ADDENDUM NO. 01 (Date: June 27, 2022)

Fairhope Sewer Upgrade Phase I

Bid No. 005-22 – Lift Station Rehabilitation

Project: Lift Station Rehabilitation, ADCNR Grant #S1P25-FSU1

SHEET NO.

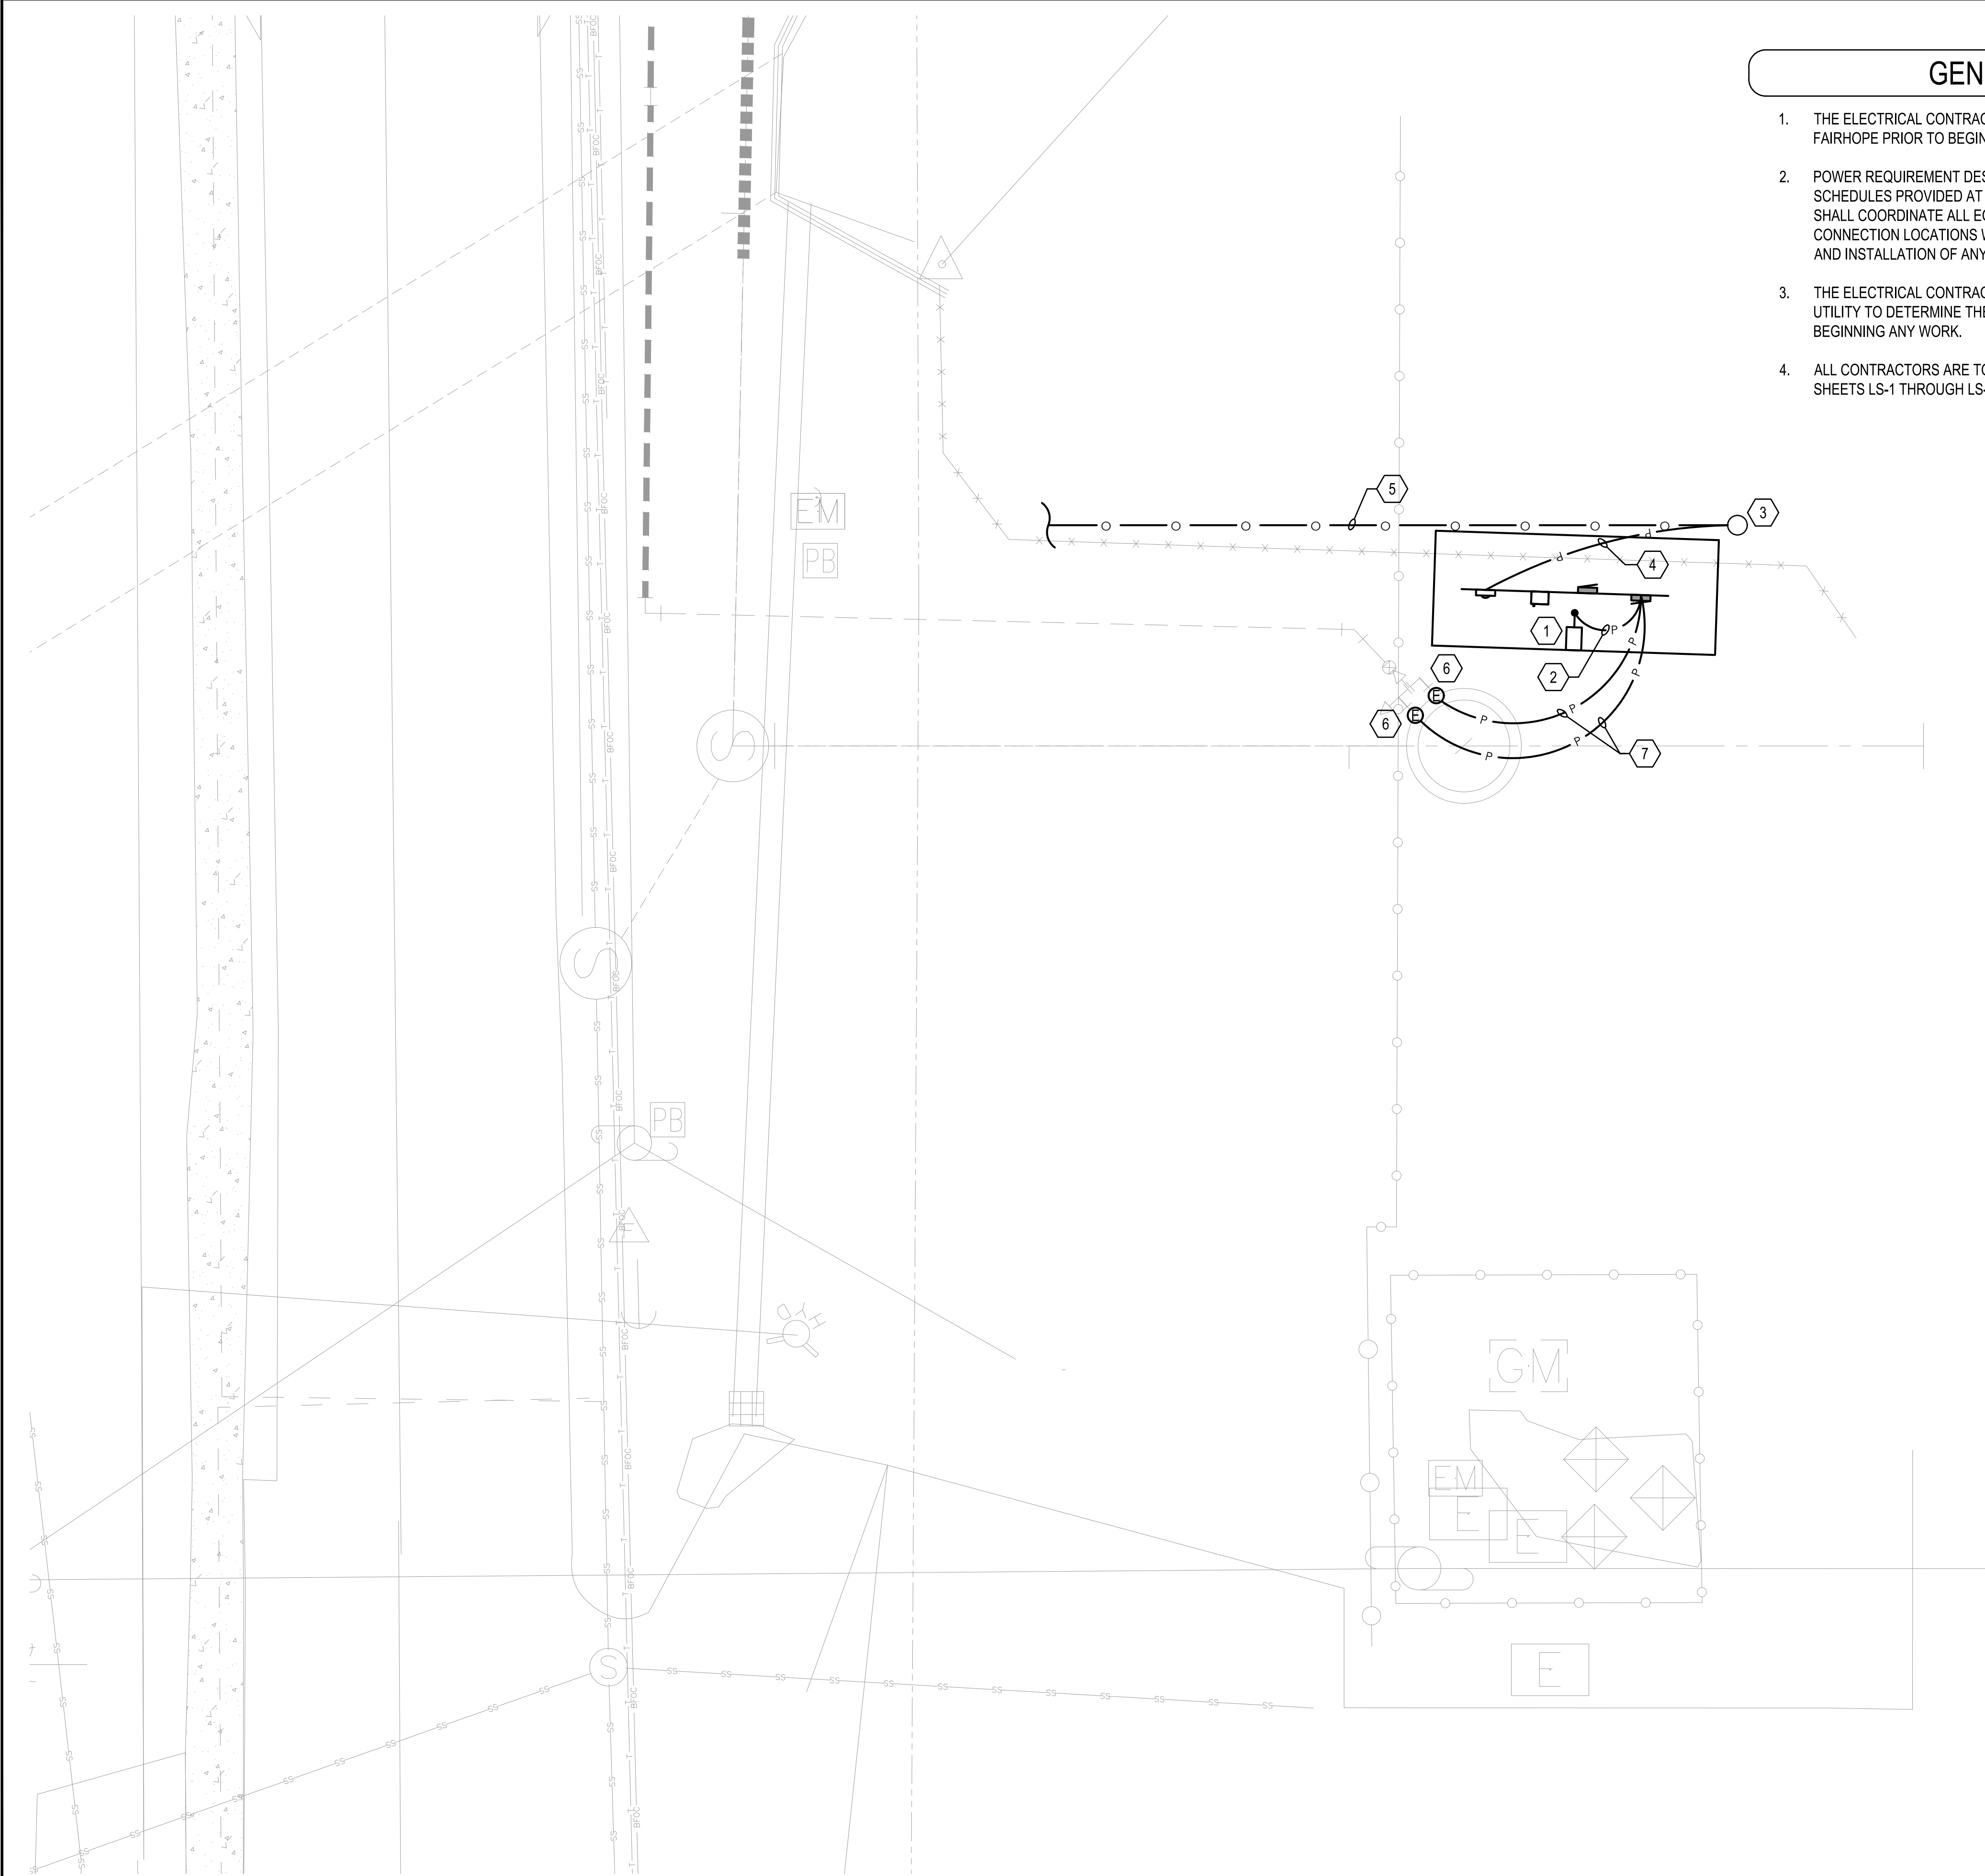
ADDENDUM #01 - DECREASED DIMENSION "A" FIBERGLASS BALLAST SIZE FROM 60" TO 48"

BALLAST DIMENSION TABLE		
BASIN TYPE	DIMENSION "A"	DIMENSION "B"
FIBERGLASS	48"	30"
CAST IN PLACE	24"	24"

SHEET:
7F

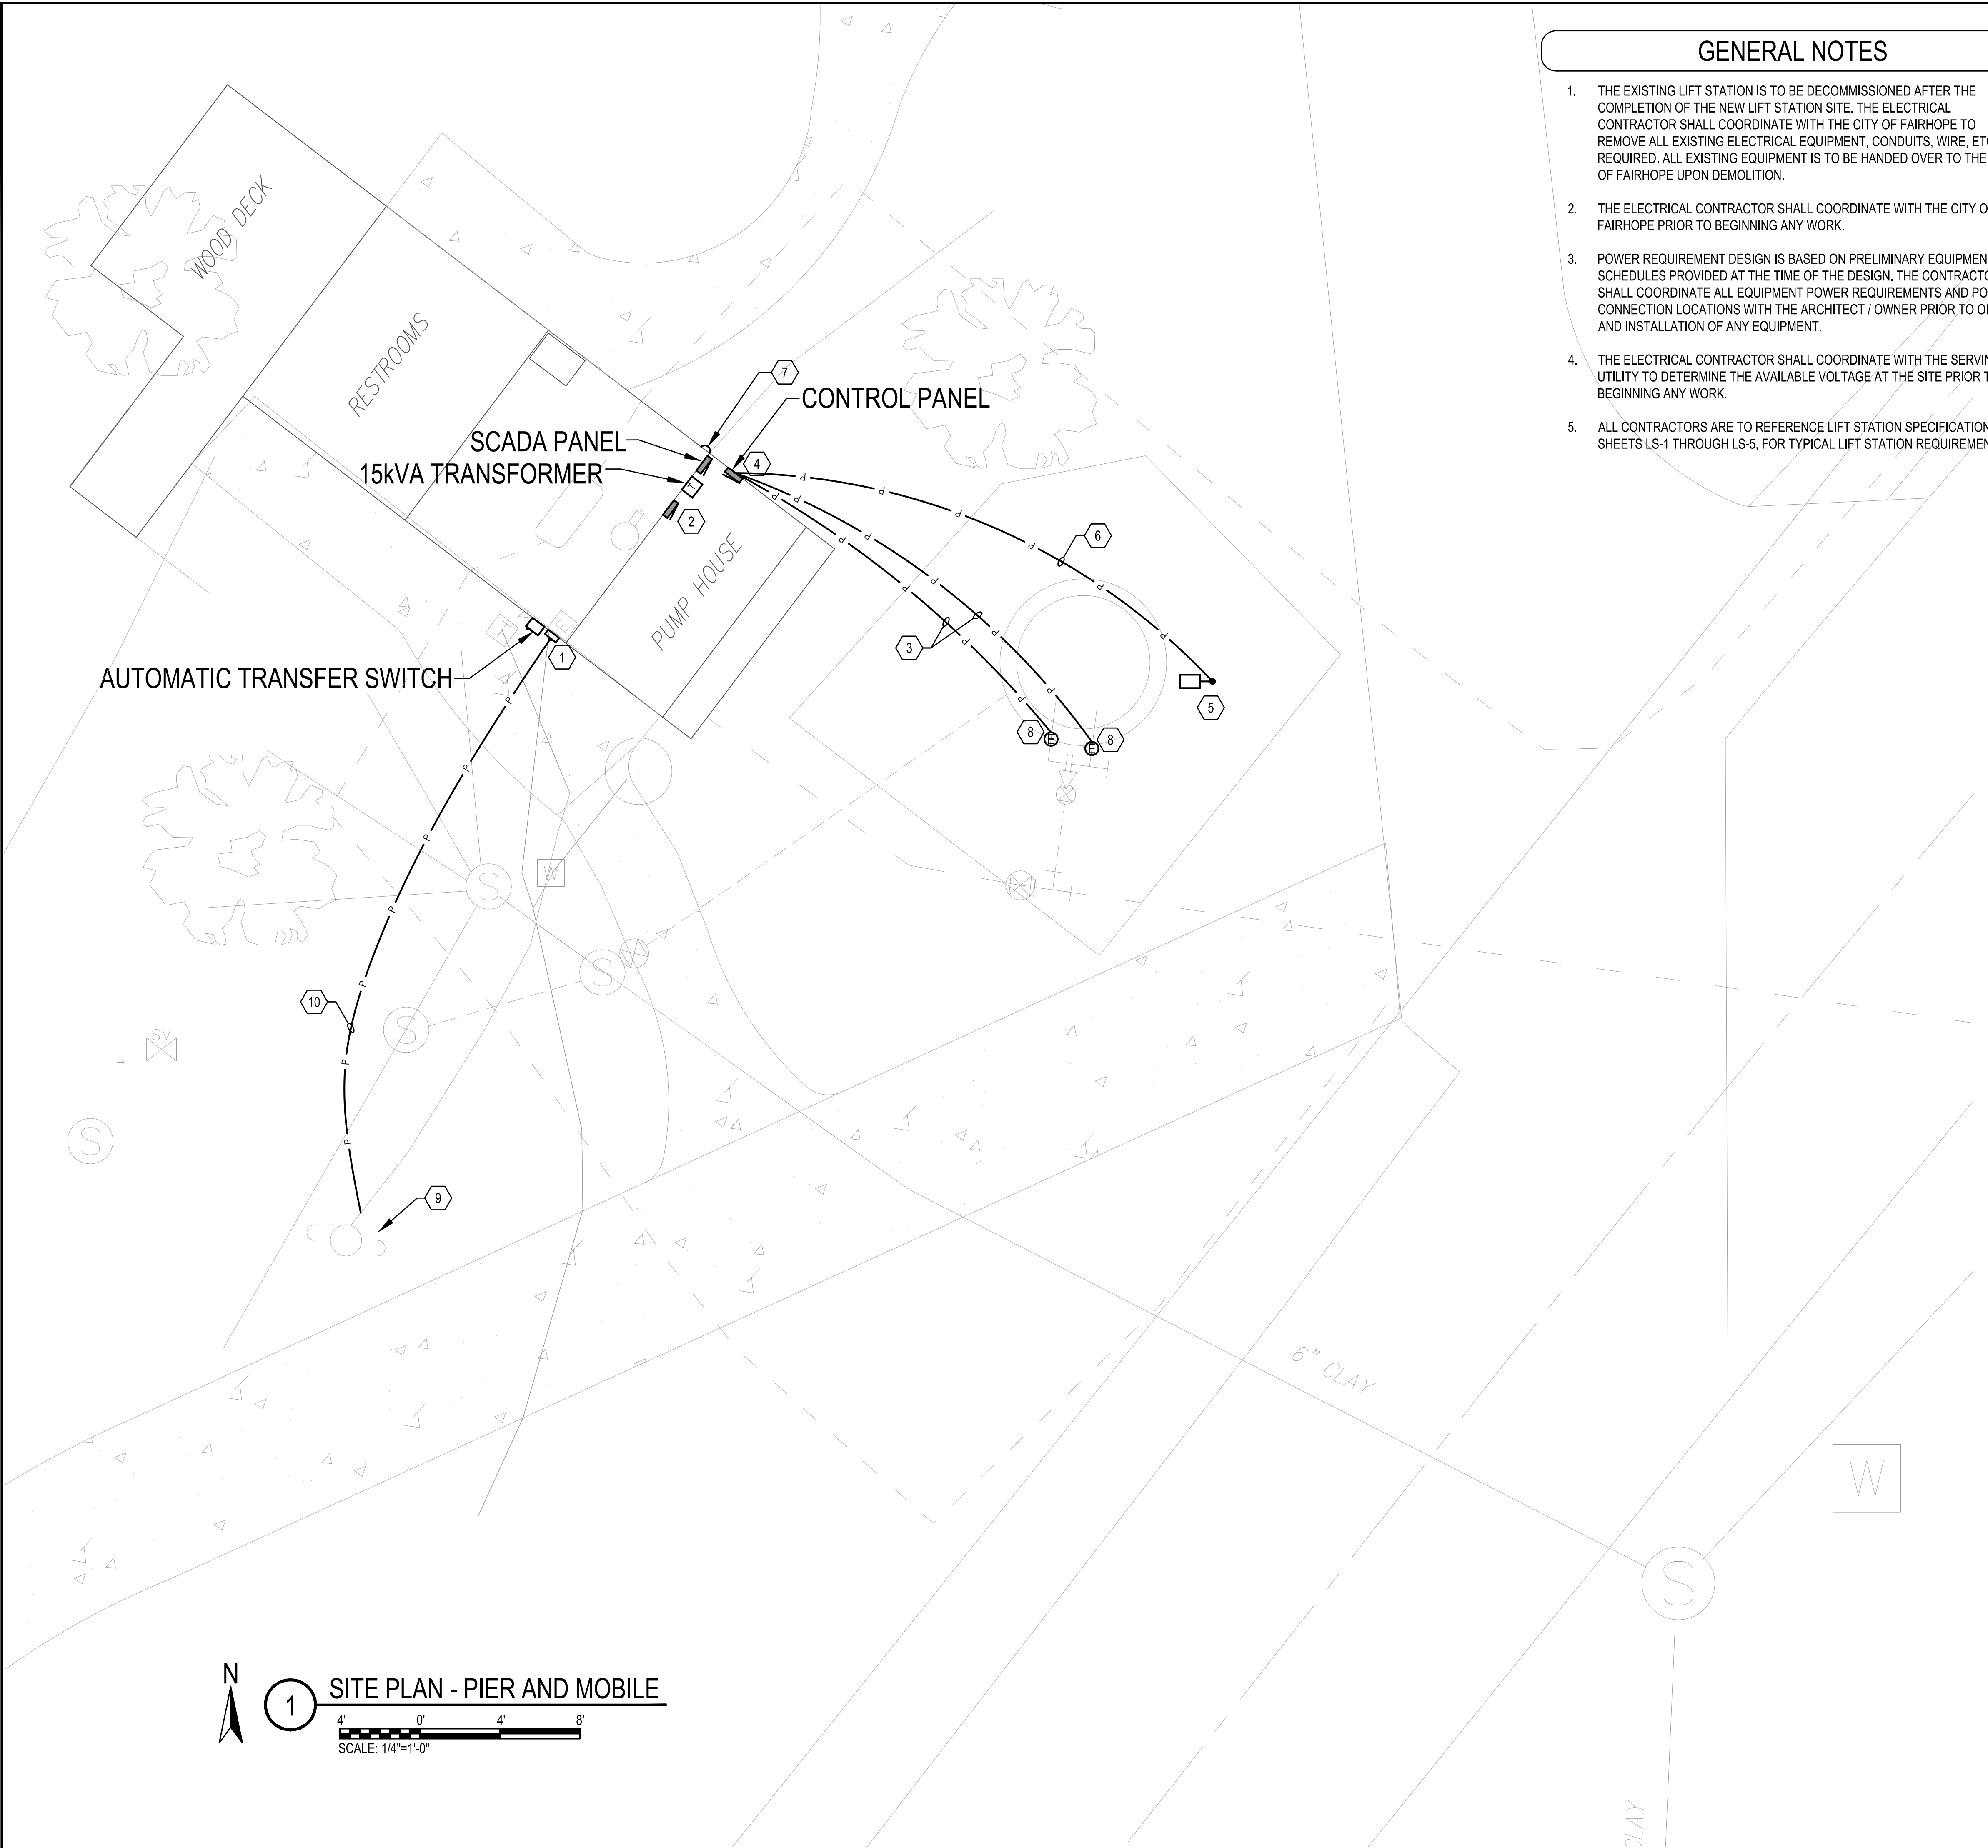
25. Question – For the South Section St. Lift Station, Sheet 7F, Note 4 calls for 2 runs of 3" conduit with 4- 350 MCM from the service pole to the transfer switch, but Sheet 7G only shows 200 amp control panel. Which will be used?

Answer: Provide 4#3/0, 2-½" conduit to feed a 200 Amp control panel. See revised plan sheet 7F attached in addendum 01 for this change. The attached plan sheet will completely replace the previous version (IFB 5/23/22) in its entirety.

SHEET:
10C

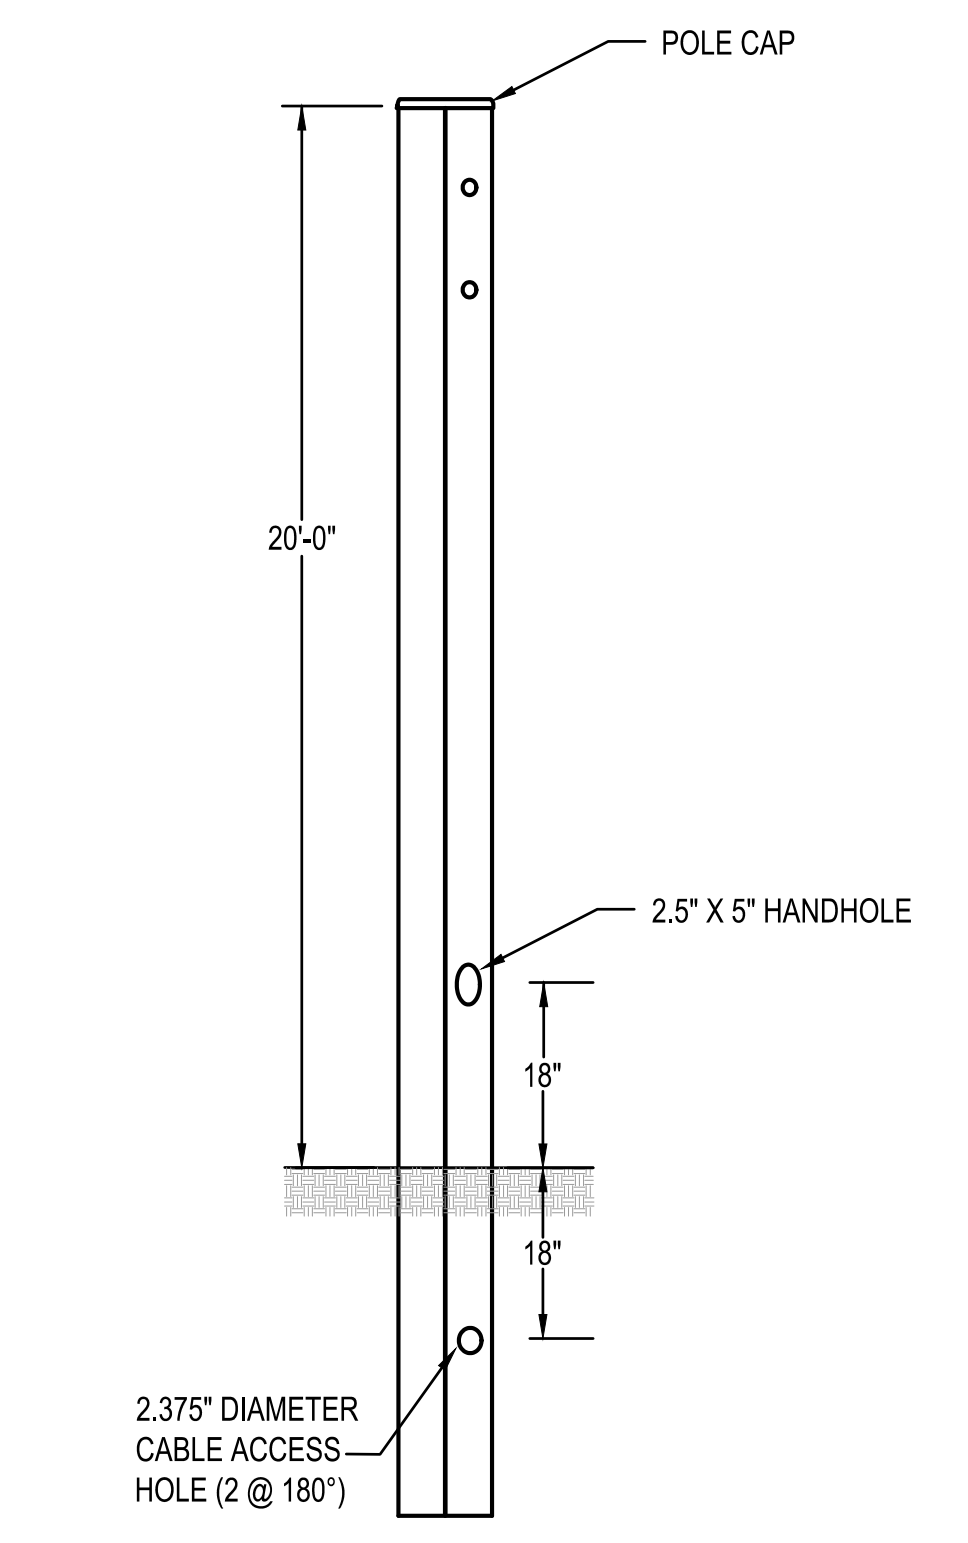
26. Question – For the Pier & Mobile St. Lift Station, Sheet 10C shows 1- 2-½" conduit with 4- 3/0 feeding a 400 Amp control panel. Is this correct?

Answer: Provide 4#500, 4" conduit to feed a 400 Amp control panel. See revised plan sheet 10C attached in Addendum 01 for this change. The attached plan sheet will completely replace the previous version (IFB 5/23/22) in its entirety.

△ 10 4#500, 4" CONDUIT, 48" BELOW FINISHED GRADE MINIMUM. COORDINATE WITH EXISTING UNDERGROUND UTILITIES PRIOR TO ROUGH-IN.
